# FPUD JOB NO. 3095 – SMRCUP Construction

## ADDENDUM D

June 26, 2019

This Addendum "D" includes clarifications and/or changes to the Contract Documents for the Fallbrook Public Utilities District, **Santa Margarita River Conjunctive Use Project Construction**

DRAWING NO.	600M-9
SHEET NO.	192 OF 387
CLIENT JOB NO.	2744

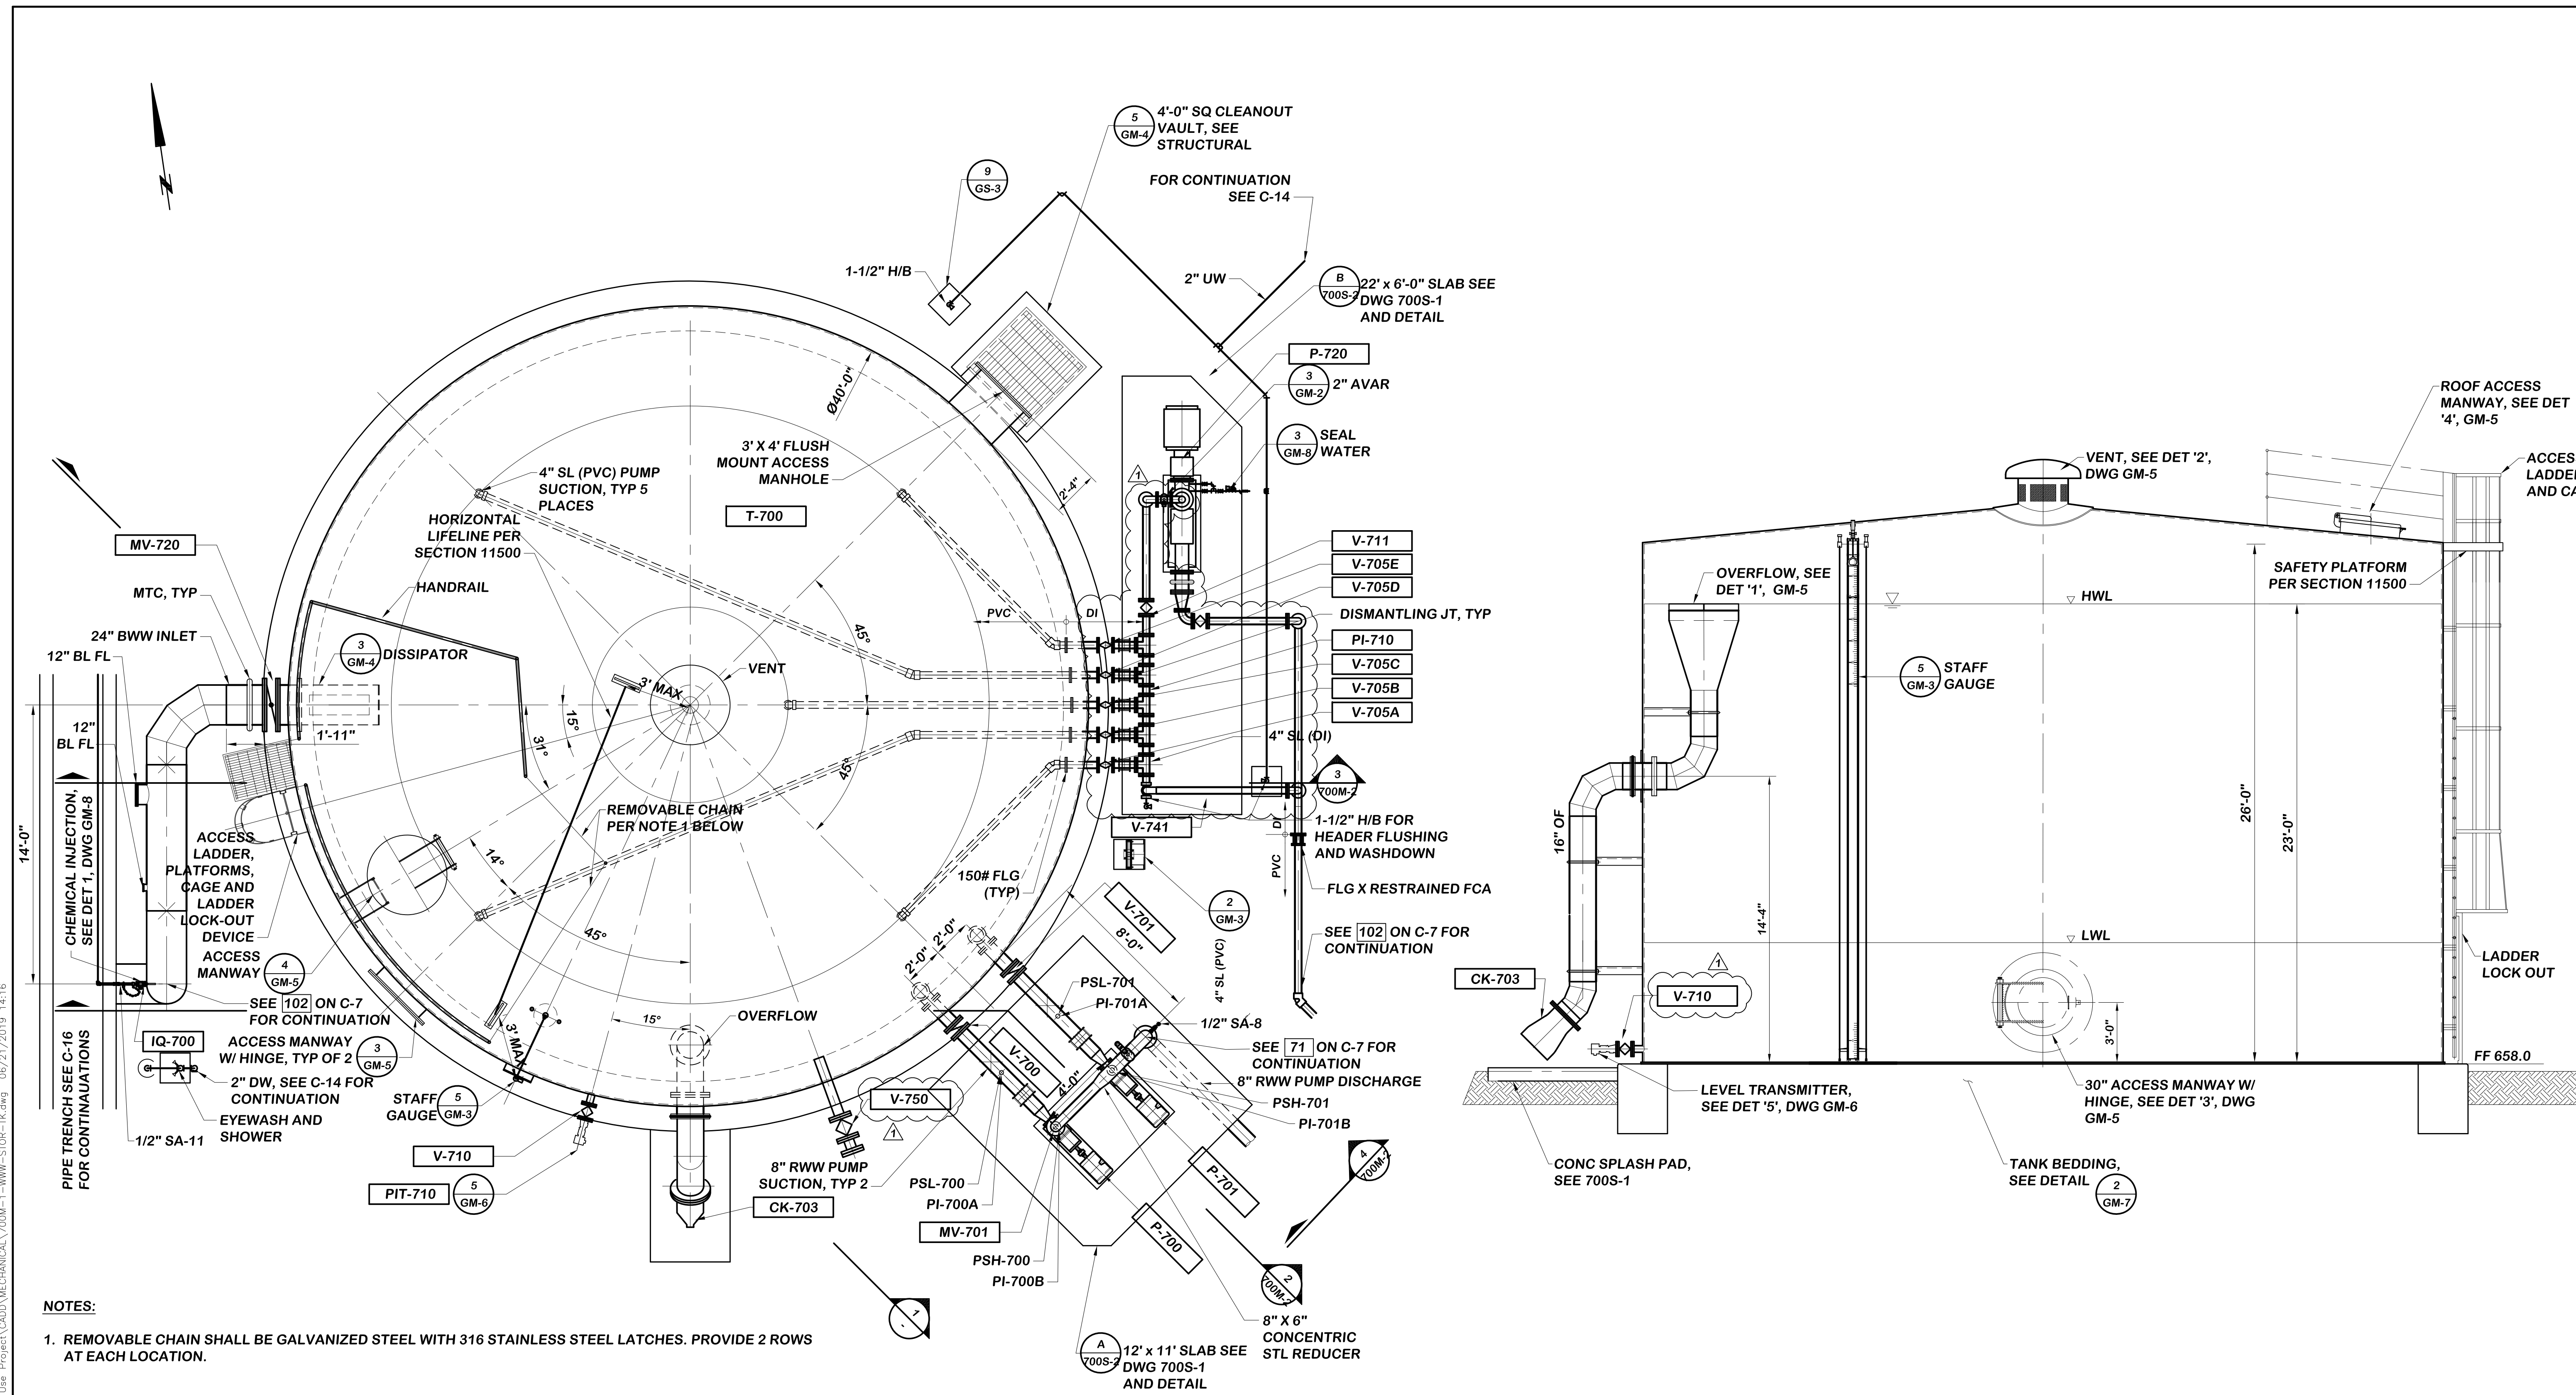
75	Per 11179-3.2.B and .C, FRP tanks are to be installed on grout layer across the entire surface of the concrete base. Elevation 2 on 600M-9 indicates "4 to 5 layers of 30# felt paper beneath the tank" with 1/2" thick grout only at the tie down lug locations per Fiberglass Tank Tie Down Lug and Clip Detail 4/600M-9. Please confirm that all the tanks listed in the Chemical Storage Tank Schedule on 600M-9 and T-400 RO CIP Tank are to be installed per details on 600M-9.	Confirmed.
76	3.8 F. defines successful completion of the 14-day test as a requisite for substantial completion. Is there a specific number of calendar days from notice to proceed associated with substantial completion similar to the 720 days for Final Completion?

230	Contract Drawing 600M-1 indicates Sulfuric Acid Tank T-660 with a 3" Tank Drain. Chemical Storage Tanks Schedule on 600M-9 indicates the Overflow and Drain for this tank as being 2 (in). Specification Section 11600-2.3.B.3.a. lists the Bottom Connection as "One 2-inch flanged flush bottom drain pipe connection". Please confirm the drain for T-660 to be 2 (in) per the Chemical Storage Tanks Schedule on 600M-9 and 11600-2.3.B.3.a	Confirmed. Drain is 2" per tank schedule on 600M-9.

RFI #	RFI Question	RFI Answer
231	Detail 5/GM-6 indicates Tank T-660 receiving a type V348 valve for the installation of a level transmitter. Per the Chemical Storage Tanks Schedule on 600M-9, T-660 does not have a Pressure Level nozzle. Specification Section 11600-2.3.B does not list a nozzle for a level transmitter on this tank. Please confirm that tank T-660 does not receive a level transmitter.	Level transmitter should be "Liquid Level Indicator Indirect Magnetic Type" per Paragraph 17329.2.6, installed as shown on 600I-9.
232	Drawing C-1 has over excavation notes that require clarification. Note 1 provides bore numbers and depths to remove the alluvium to the satisfaction of the inspector. The removal of existing fill is defined only at the bore location, with no boundary or area limit defined. Note 2 states "extent of over excavation for treatment plant site shall extend within the plant perimeter road limits." This too is vague and subjective. Note 3 states "over excavate, scarify and compact in accordance with the Geo-tech report and 02200. The geo-tech reports and section 02200 give differing directions on over excavation. The 4th note states for bidding purposes assume an over excavation quantity of 16,000 cy. In lieu of clear direction we are proceeding with these assumptions: 1.Where no fill is required under structure we will clear & grub per 02200, over excavate 1 foot, scarify, compact, and construct per the structural drawings 2.Where fill is required under structures we will clear & grub per 02200, scarify, compact, and place fill to bottom of structure and construct per the structural drawings 3.Where there are no structures and fill is required we will clear & grub per 02200, scarify, compact, and place fill to subgrade of surface finishes. Please advise.	Reference is made to the General Conditions, Article 55, Soils Investigations. <b>Make the following modifications to the Contract Documents.</b> SPECIFICATION SECTION 02200 - EARTHWORK REPLACE the specification section in its entirety with Section 02200 attached hereto.

DRAWING NO. **C-11**

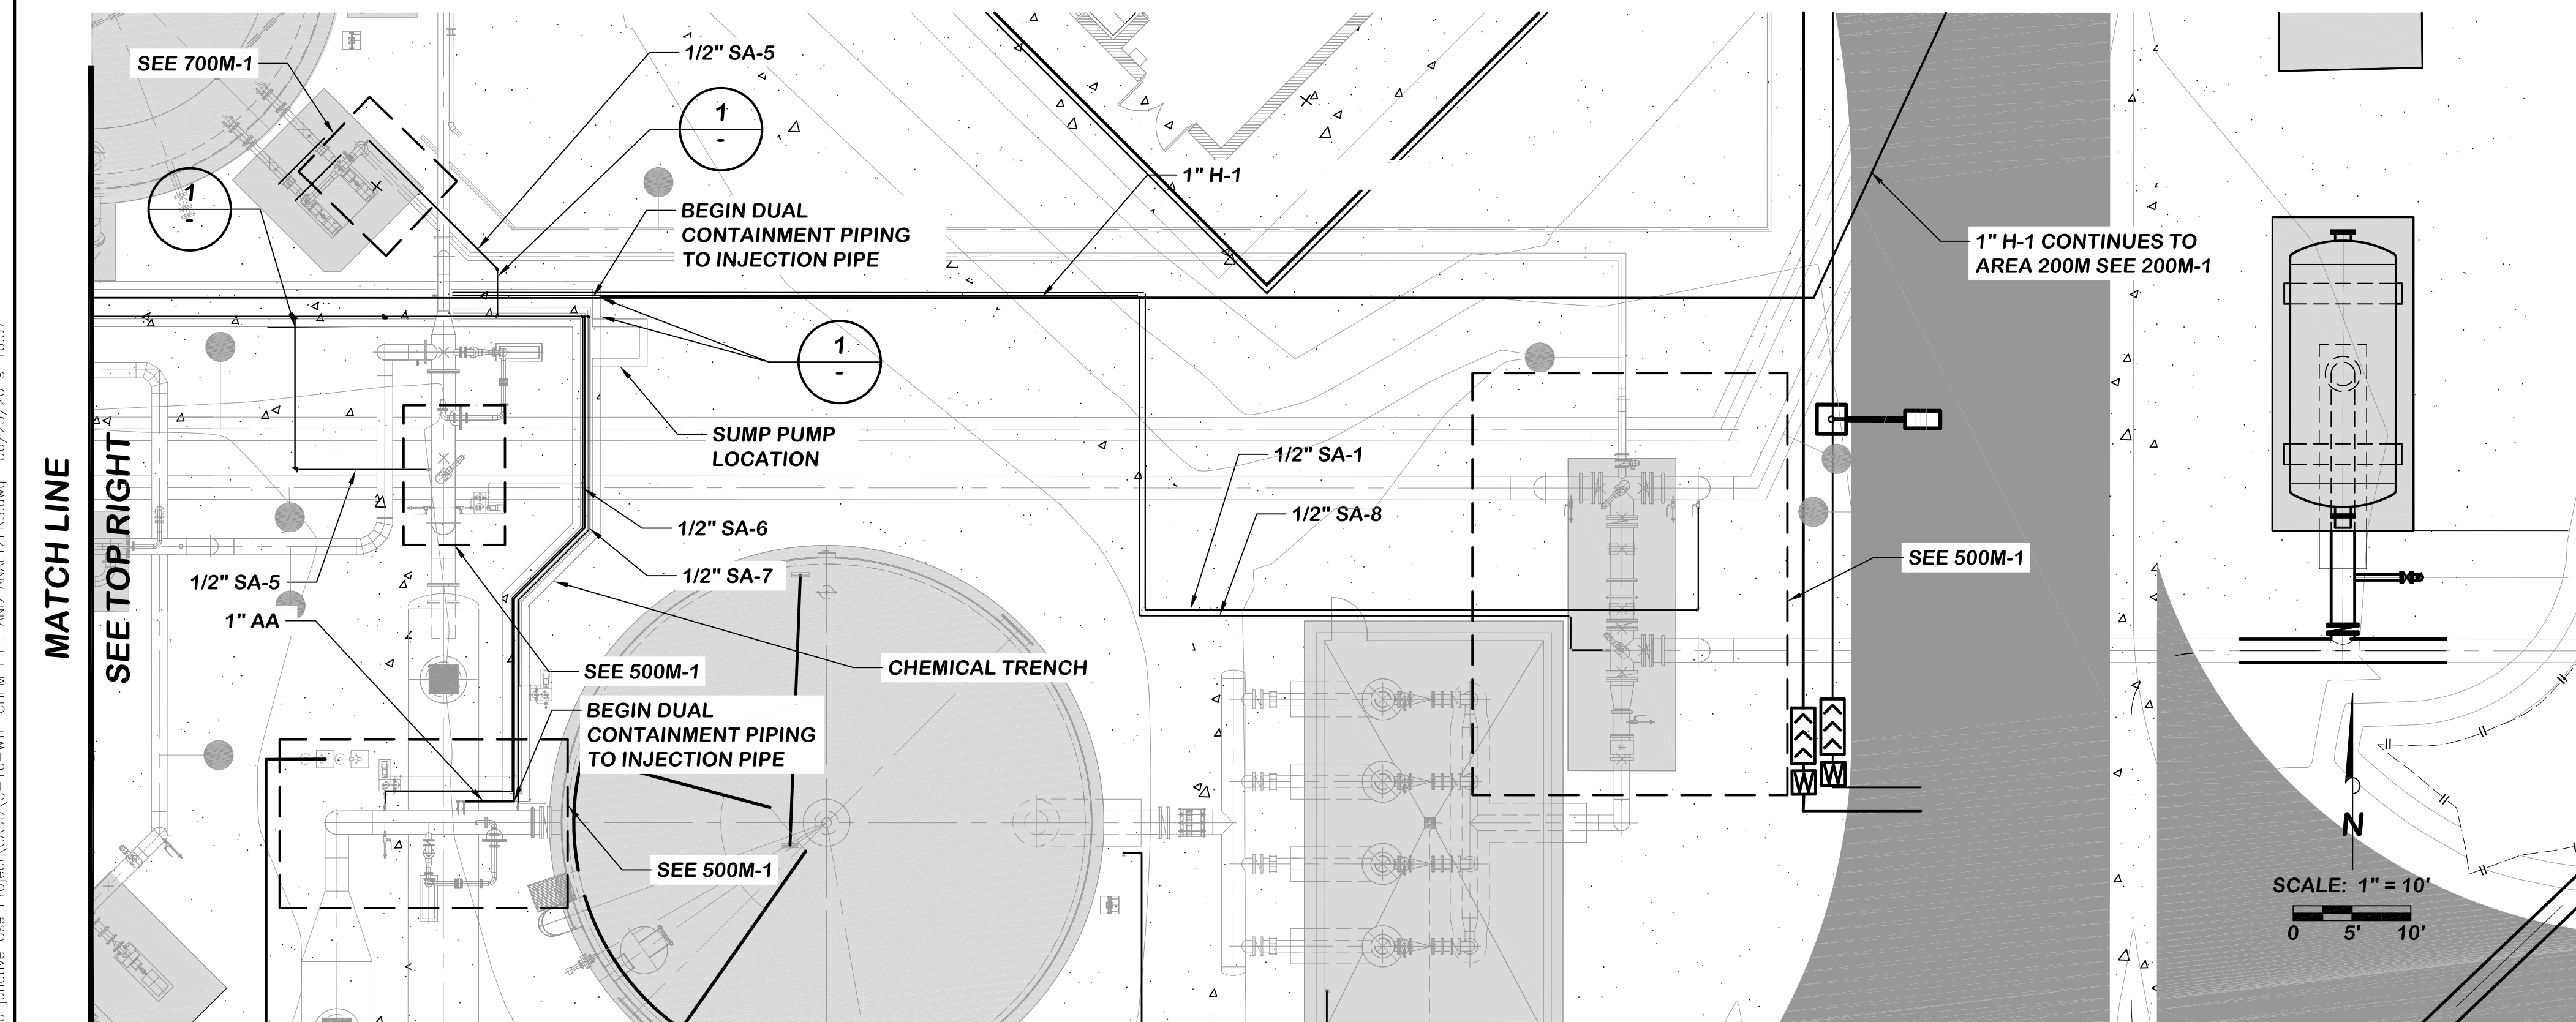
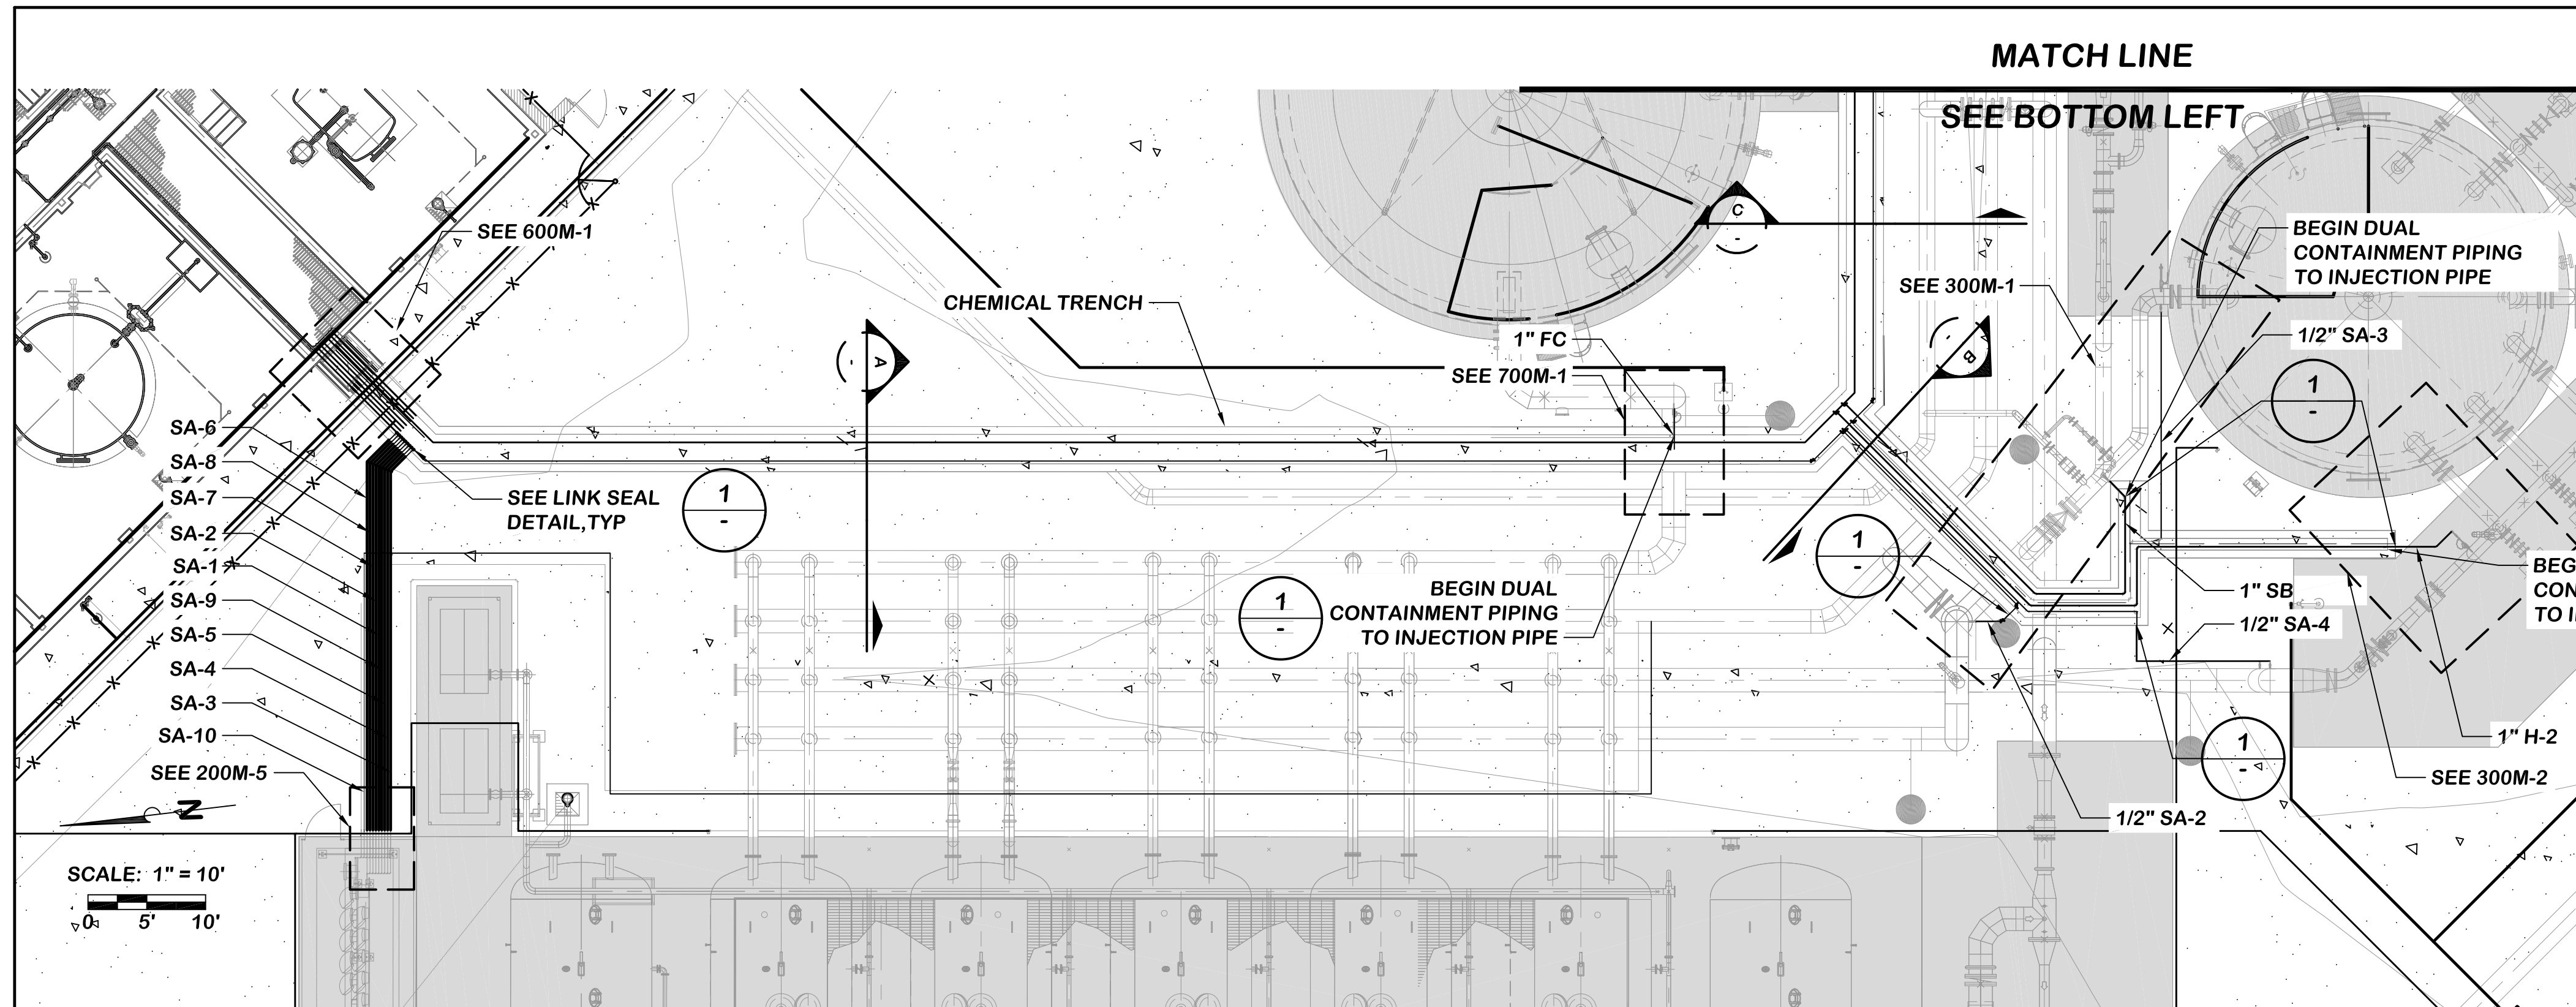
261	The Valve List calls out valves #V-730A & B. These valves are not shown on drawing 700M-4. Please advise location.	Valve are buried and located at sludge beds. See revised C-11.
262	GFM-1 shows valve #V-810 at the tank level transmitter assembly. Please confirm that this valve is a 4" V6 Gate Valve, per Detail 5/GM-6.	Confirmed. See expanded valve schedule by addendum and revised sheet GM-6.
263	Please provide the Davis Bacon Wage Determination for this project. The Davis Bacon CA190001 5/3/2019 report looks to have an error specifically with the Millwright Journeyman. This report has a \$6.00 an hour higher rate than CA DIR and the Union CBA. With the amount of millwright work required for this project it is in the Owner's best interest to correct this rate accordingly.	
264	Spec section 16250 indicates Manual Transfer Switch in the header but automatic transfer switch on the footer. The accessories listed are typically provided on automatic transfer switches. Single line drawing GE-3 indicates the 4000A switch is an ATS but in parentheses indicates (manual operation). Single line drawing GFE-2 indicates the 800A switch is an (MTS with manual operation) in parentheses. Please clarify what each switch is supposed to be automatic, manual or non-automatic (non-auto is manual but still electrically operated) operation.	Switches at both sites are to be Automatic Transfer switches, For initial operation they are to be operated in manual mode since portable generators will be used for the immediate future. FPUD wants option for automatic transfer in the future if they decide to place generators at the sites permanently.
